CITY OF RIVERBANK

RIVERBANK ARMY AMMUNITION PLANT SPECIFIC PLAN EIR

NOVEMBER 2013 | FINAL EIR

FIGURE 4.3-2

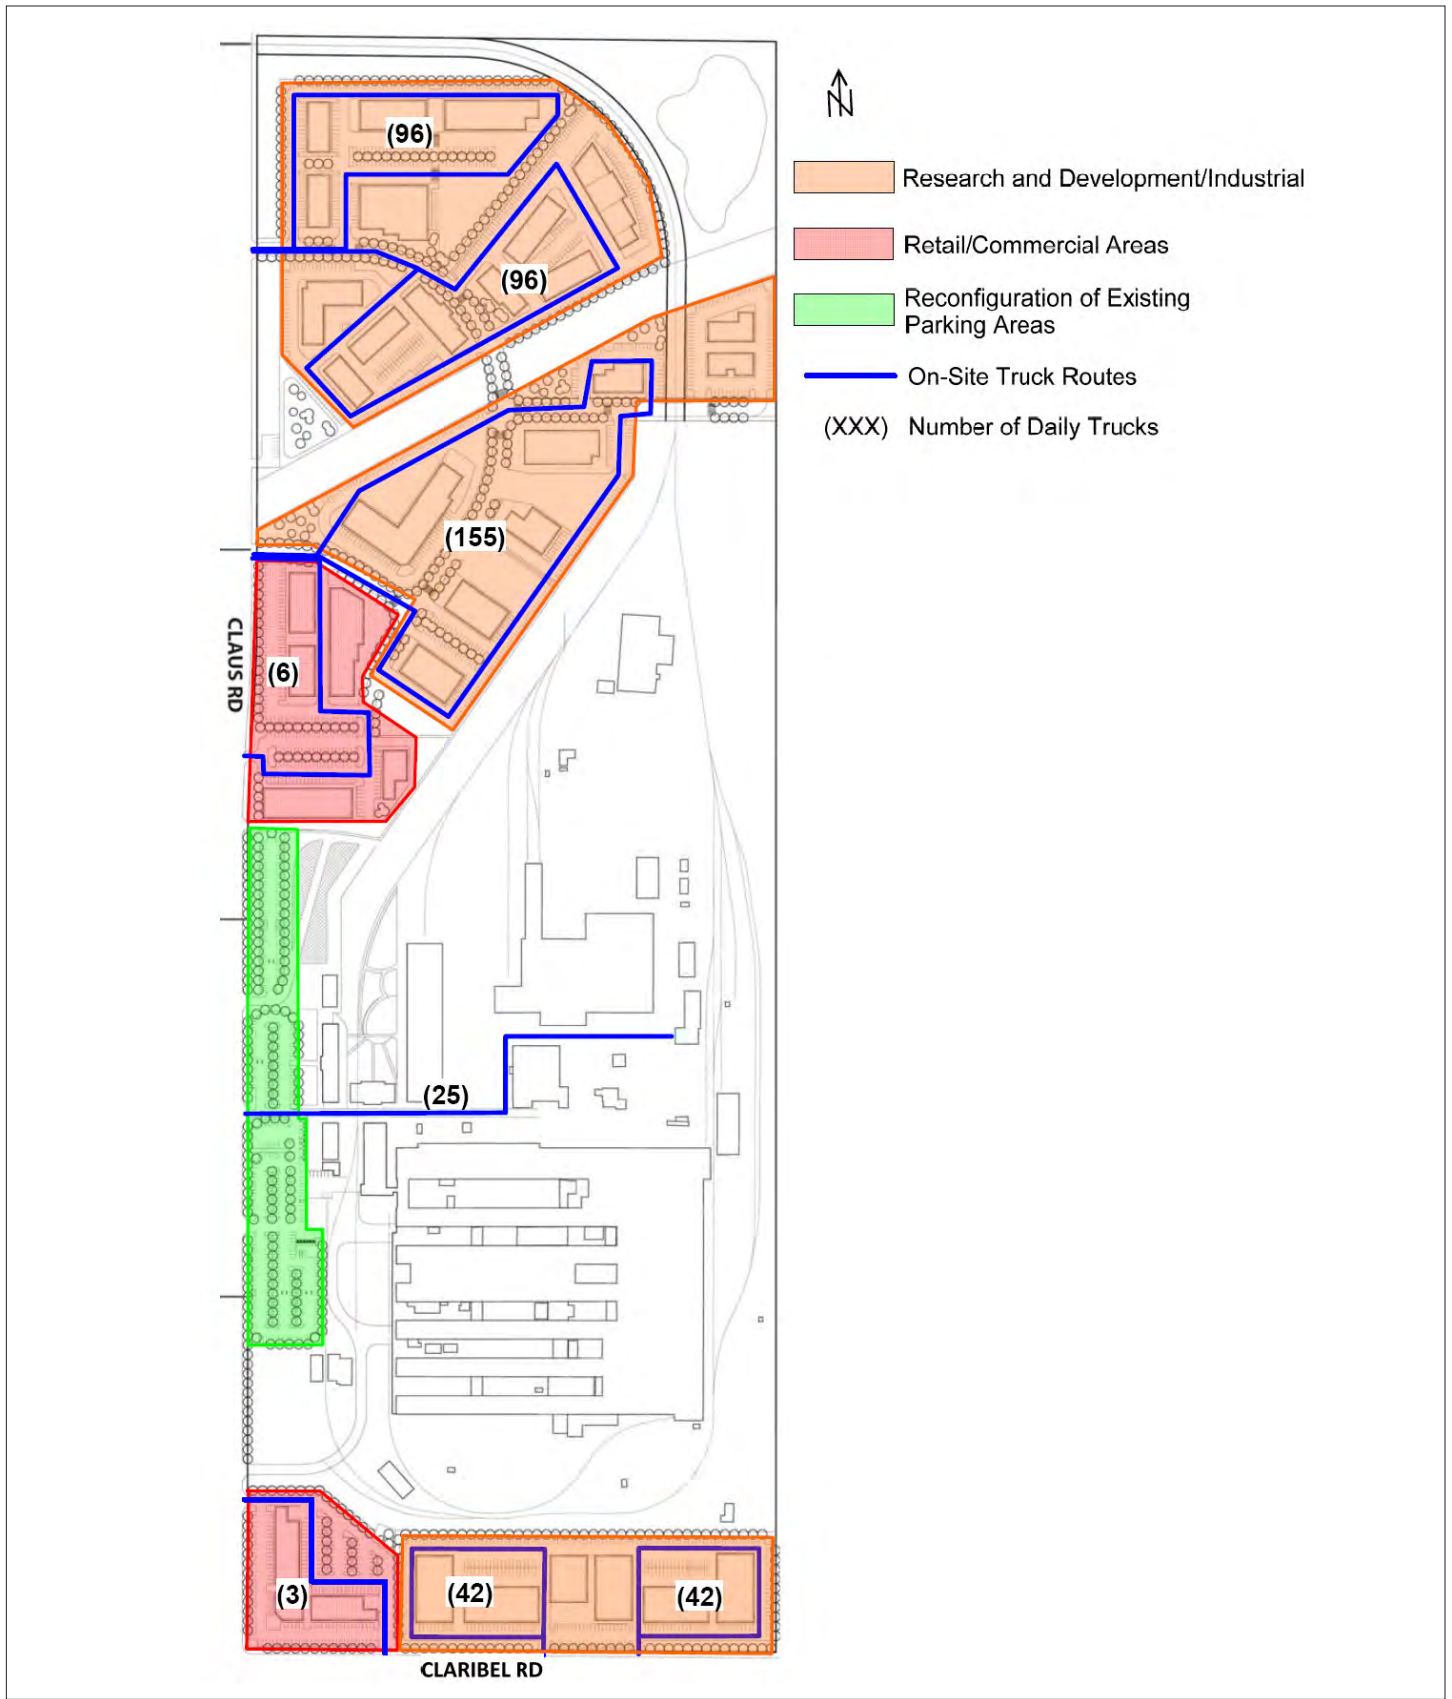
Section E.1.d. beginning on page 4.3-32 of the Draft EIR is hereby added as included below. As a part of the text edits below, Figure 4.3-2 and Figure 4.3-3, have been added to the Draft EIR and are also include below. In addition, Appendix B (attached to this Final EIR) has been modified to include additional information pertaining to the Health Risk Assessment.

The health risk evaluation for the Specific Plan involved the calculation of future diesel particulate matter (DPM) emissions and associated health risks for on-site vehicle traffic at the project site~~for traffic on Claus Road, which is the main road adjacent to the project site. It was assumed that the primary contributor to potential health risks from on-site traffic would be from DPM emissions from diesel-fueled trucks.~~ Emissions were calculated using the latest version of the CARB EMFAC2011 emissions model. Potential cancer risks for residents in the vicinity of the project site~~along Claus Road~~ were calculated using health risk assessment methods recommended by the California Office of Environmental Health Hazard Assessment¹ (OEHHA) and the SJVAPCD.¹. The health risk assessment method includes calculation of ambient DPM concentrations at residential receptor loca-
